KONYA BÜYÜKŞEHİR BELEDİYESİ

**PROCUREMENT OF GOODS AND RELATED SERVICES FOR 4 ELECTRICAL
MULTIPLE UNITS (16 CARS) FOR KONYA COMMUTER OPERATION PROJECT
(IDB-KON-G01)**

CLARIFICATION NO:1

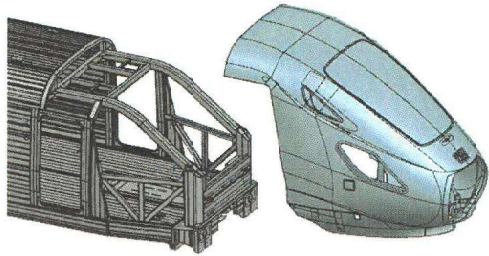
11	Technical Specifications pp.170-173; Section VII pp.89-91	TECHNICAL SPECIFICATION 11.2.1 TABLE 4 TRAIN SET LOCAL CONTENT PERCENTAGE TABLE (4 CARS PER SET)	In the Technical Volume, under Clause 11.2.1 "Percentage Table of Local Content per Trainset (4 Cars per Trainset)", the sum of the individual percentage items is 97%, rather than 100%. We propose either to add a new item "Bogie Assembly" with the type "Service" and a ratio of 3%, or to adjust the ratio of "Assembly / Installation" from 7% to 10%. Please confirm whether this proposal is acceptable.	The proposal to increase Item 3, Assembly / Installation, from 7% to 10% is accepted, bringing the total of Table-4 to 100%. No new Bogie Assembly item is added. Item 12, Train Control System Including Software, remains 3%. Please see Addendum No.2, Amendment No.1	YES
12	Technical Specifications pp.170-173; Section VII pp.89-91	TECHNICAL SPECIFICATION 11.1.1.2DESIGN AND ENGINEERING 11.2.1 TABLE-4 11.1.1.2Design and Engineering If the vehicle supplier is a local company or has an affiliated local company (in joint ventures, the leading/pilot firm must be a local company), the "Design and Engineering" service shall be considered a local service. 11.2.1 TABLE-4	According to the description in clause 11.1.1.2 "Design and Engineering", Design and Engineering is defined as a local service. However, in Table-4 under clause 11.2.1, the type of "Design and Engineering" is listed as "Equipment", which is inconsistent with the description in clause 11.1.1.2. Furthermore, "Design and Engineering" cannot be certified with a local product certificate. Based on the definition of "Design and Engineering" in previous tender documents for Turkish projects, we propose that the type of "Design and Engineering" in Table-4 under clause 11.2.1 be revised from "Equipment" to "Service". Please confirm whether this proposal is acceptable.	Accepted. In Table-4, the Type of Design and Engineering is corrected from Equipment to Service. Please see Addendum No.2, Amendment No.1.	YES

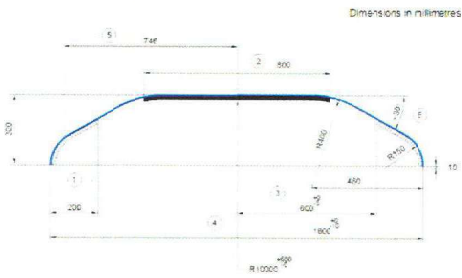
23	Technical Specifications, p.81	TECHNICAL SPECIFICATIONS 5.3.2.4.5 The energy generated by the dynamic braking shall be fed back to the line, and if the line is not a receiver, it shall be dissipated through the brake resistors. In service braking, it shall be preferable to use dynamic braking (electro-dynamic motor brake) as	The AC traction system, by virtue of its inherent four-quadrant converter and transformer configuration, enables direct regenerative braking energy feedback to the grid, thus eliminating the need for onboard braking resistors. Braking resistors are typically activated only when the line is unable to accept regenerated energy, and such occurrences are relatively infrequent; therefore, braking resistors are not generally fitted on current mainstream EMUs. In the event that energy feedback is not possible, the braking system will smoothly transition to air braking and	The proposal is not accepted. The requirement that regenerated energy be dissipated through braking resistors when the line is not receptive remains applicable. Pneumatic braking may supplement the braking process as required by the blended-braking strategy, but it shall not replace the specified braking-resistor function.	NO

No.	Bidding Document / Page	Reference Clause	Query or Clarification Requested by Prospective Bidders	Reply of the Employer	Amendment Required
		much as possible.	complete the entire braking process using air braking. The omission of braking resistors can reduce the vehicle weight by 1 to 2 tonnes, lower overall energy consumption, and also avoid the cleaning and maintenance of associated cables, modules, and ventilation devices, thereby reducing maintenance workload. In view of the above, we propose that the relevant clause be revised as follows: "If the line cannot receive the regenerated energy, the energy shall be dissipated via braking resistors, or alternatively, the braking process shall be completed by smooth transition to air braking." Please confirm whether our proposal is acceptable.		
24	Technical Specifications, pp.85-86	TECHNICAL SPECIFICATIONS 5.4.1.1 The vehicles shall have a heating, ventilation and air conditioning system to ensure passenger comfort. Design of the air conditioner and its application to passenger compartments shall comply with the conditions specified in standards EN 14750-1, EN 14750-2, EN 779:2002, EN 50155, EN 50121, EN 50126, EN 50128, EN 50153, EN 60038, IEC 61287-1, and IEC 61287-2.	EN 779:2002 has been superseded, and current mainstream EMU designs have adopted EN ISO 16890-1:2016 as the replacement. Please confirm whether this is acceptable.	Accepted. EN 779:2002 is replaced by EN ISO 16890-1:2016, or its latest applicable version, for air-filter classification. The HVAC reference is also aligned with EN 14750:2024, or its latest applicable version, which replaces EN 14750-1 and EN 14750-2. The specified climatic, loading, comfort and noise requirements remain applicable. Please see Addendum No.2, Amendment No.5.	YES

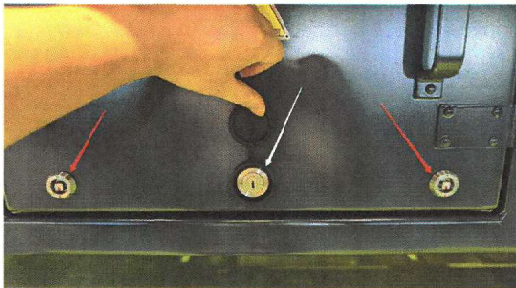
25	Technical Specifications, p.85	TECHNICAL SPECIFICATIONS 5.4.1.4 The coefficient of performance (COP) and the energy efficiency ratio (EER) of the HVAC units to be mounted on the proposed vehicle shall be higher than 1.6.	The document requires that, under an ambient temperature of -10 °C, the interior temperature of the vehicle be maintained between +15 °C and +17 °C. The air-conditioning unit provides heating through two methods: heat pump and electric heating. In heat-pump mode, the outdoor heat exchanger absorbs heat from the air, which is transferred via refrigerant to the indoor heat exchanger to warm the passenger compartment. However, this method is significantly affected by the ambient temperature: when the outside temperature is higher, the coefficient of performance (COP) is relatively high; when the temperature falls below 0 °C, compressor losses increase, the COP decreases notably, and the outdoor heat exchanger is prone to frosting, which is unfavourable for heat-pump operation. In electric-heating mode, electrical energy is directly converted into heat, which is not affected by ambient temperature, but the COP is less than 1. Therefore, it is recommended that for heating, different COP requirements be set for different ambient	The proposal is not accepted. The specified COP and EER requirement remains applicable and shall be demonstrated under the rating and test conditions of the applicable HVAC standards. The use of auxiliary resistance heating at low ambient temperature does not waive the performance requirement for the HVAC unit or the specified passenger-compartment temperatures.	NO

No.	Bidding Document / Page	Reference Clause	Query or Clarification Requested by Prospective Bidders	Reply of the Employer	Amendment Required				
			temperatures: when the outside temperature is above 0 °C, COP > 1.6; when the outside temperature is between -10 °C and 0 °C, COP < 1.						
26	Technical Specifications, p.85	TECHNICAL SPECIFICAT IONS 5.4.1.5 The system shall be highly efficient, low-noise, and maintenance friendly and it shall be possible to adapt it various operating conditions. The noise level inside the cabin shall not exceed 65 dBA. Noise levels measured in a parked vehicle with active HVAC units at a height of 1.6 m from the floor anywhere within the vehicle shall not exceed the following values: When heating functions normally: 60 dBA When heating functions at maximum: 63 dBA When cooling functions normally: 63 dBA When cooling functions at maximum: 65 dBA	The main sources of noise from the air-conditioning unit are the supply fan, compressor, and condenser fan. According to EN 14750-1, under the condition of full seating and a standing passenger density of 2 persons/m², the noise generated solely by the air-conditioning equipment shall not exceed 66 dBA. <table border="1"><thead><tr><th>Category A</th><th>Category B</th></tr></thead><tbody><tr><td>63 dB(A)</td><td>66 dB(A)</td></tr></tbody></table> The passenger load required for this project is AW3 (full seating + standing passengers at 6 persons/m²), which is higher than 2 persons/m². This increases the required fresh air volume and passenger heat gain; combined with the high ambient temperature, it leads to an increase in the required cooling (or heating) capacity and air supply volume, higher pressure heads for the supply fan and condenser fan, and greater compressor capacity, all of which result in a significant rise in ncise generation. Therefore, based on standard EN 14750-1, the noise level shall not exceed 66 dBA under all operating conditions except at maximum cooling, where it shall not exceed 68 dBA, as shown below: The system shall be highly efficient, low-noise, and maintenance friendly and it shall be possible to adapt it various operating conditions. The noise level inside the cabin shall not exceed 68 dBA. Noise levels measured in a parked vehicle with active HVAC units at a height of 1.6 m from the floor anywhere within the vehicle shall not exceed the following values: When heating functions normally: 66 dBA When heating functions at maximum: 66 dBA When cooling functions normally: 66 dBA When cooling functions at maximum: 68 dBA	Category A	Category B	63 dB(A)	66 dB(A)	The proposal is not accepted. The noise limits stated in Technical Specification Clause 5.4.1.5 remain applicable, including the maximum value of 65 dBA. The Bidder shall size and design the HVAC system to satisfy the specified AW3, climatic, comfort and noise requirements simultaneously.	NO
Category A	Category B								
63 dB(A)	66 dB(A)								
27	Technical Specifications, p.86	TECHNICAL SPECIFICATIONS 5.4.1.7 The capacity of the HVAC system shall be determined by considering the number of passengers in the	EN14752 is about the Bodyside entrance systems for rolling stock. Please clarify whether the requirements for calculating the fresh air volume shall comply with EN14750.	Confirmed. The reference to EN 14752 is a clerical error. Fresh-air calculations shall comply with EN 14750:2024, or its latest applicable version, which replaces EN 14750-1 and EN 14750-2. The specified AW3 load and other HVAC performance requirements remain applicable. Please see Addendum No.2, Amendment No.6.	YES

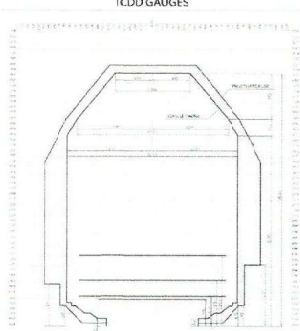
37	Technical Specifications, p.95	TECHNICAL SPECIFICATIONS 5.5.2.1.7 Each vehicle shall have earthed sockets of the 230 VAC - 50 Hz / 16 A line. The number and locations of these sockets shall be agreed jointly with the Administration.	Please confirm whether this socket is intended for use by on-board maintenance/cleaning equipment.	Confirmed. The 230 VAC, 50 Hz, 16 A earthed sockets are intended for authorised onboard maintenance and cleaning equipment. Their number, locations, protection and labelling shall be agreed with the Purchaser during design review.	NO
38	Technical Specifications, pp.96-97	TECHNICAL SPECIFICATIONS 5.5.2.2.9 Accumulators shall be able to be charged from external sources of 220 VAC-50 Hz. or 3x400 VAC-50 Hz when necessary. A plug-and-socket system suitable for this purpose shall be used.	Please clarify the specific requirements for the external charging interface of the battery: The specification states that the battery can be charged from an external power supply of either 220 VAC-50 Hz or 3x400 VAC-50 Hz. Please confirm whether the vehicle is required to be compatible with both power supply types simultaneously, and whether the Owner is expected to provide corresponding ground power supply equipment (ground chargers) on site for both supply configurations. Please confirm the standard type of plug/socket for the external charging interface and its installation location.	The vehicle shall include the complete onboard external-charging interface, plug-and-socket arrangement and charging cables. Clause 5.5.2.2.9 permits charging from 220 VAC, 50 Hz or 3 x 400 VAC, 50 Hz; the final configuration, connector standard and installation locations shall be proposed by the Supplier and approved during design review. The Bidder shall not assume that Purchaser-supplied, bidder-specific ground chargers will be available; any special ground equipment required by the proposed solution shall be clearly identified and priced.	NO

No.	Bidding Document / Page	Reference Clause	Query or Clarification Requested by Prospective Bidders	Reply of the Employer	Amendment Required
39	Technical Specifications, p.96	TECHNICAL SPECIFICATIONS 5.5.2.2.12 It shall be guaranteed that emergency lighting will last 3 hours and provide at least 5-lux lighting at floor level. In the event of a fire, the emergency lighting system will be able to maintain that at least 50% of the emergency lighting in vehicles is not affected by fire for at least 20 minutes. This requirement will be deemed to have been fulfilled by a satisfactory failure mode analysis. Values and test methods for specific areas are described in EN 13272 and shall be observed. Therefore, this aspect shall be taken into account while calculating the accumulator capacity.	The technical specification only specifies that the emergency lighting shall operate continuously for 3 hours and that the door operation time is 10 minutes. However, for other emergency loads (such as ATS/ETCS, train control and monitoring system, radio/GSM-R, brake control, fire alarm system, etc.), the battery power supply duration is not specified. Since the battery capacity calculation shall be based on the power and the supply duration of each load, please specify the required operating duration under battery power for each emergency load.	Accumulator capacity shall be determined in accordance with Clause 5.5.2.2 and the Accumulator (Battery) Capacity Test, taking account of the applicable standards and all specified loads. The 3-hour design guarantee at a minimum of 5 lux applies to emergency lighting. In the capacity test, batteries charged to 80% shall supply the emergency lighting loads for at least 1.5 hours at a minimum of 5 lux, including 5 minutes of full lighting. The stated 10-minute requirement for door mechanisms and controls and 30-minute requirement for emergency fans remain applicable. For the other loads, the Bidder shall substantiate the required supply durations and duty cycles under the relevant standards and operating and safety requirements in the accumulator sizing calculation submitted for the Purchaser's approval. This reply does not assign the emergency-lighting test duration to every other emergency load or introduce a new common duration. No amendment is made.	NO
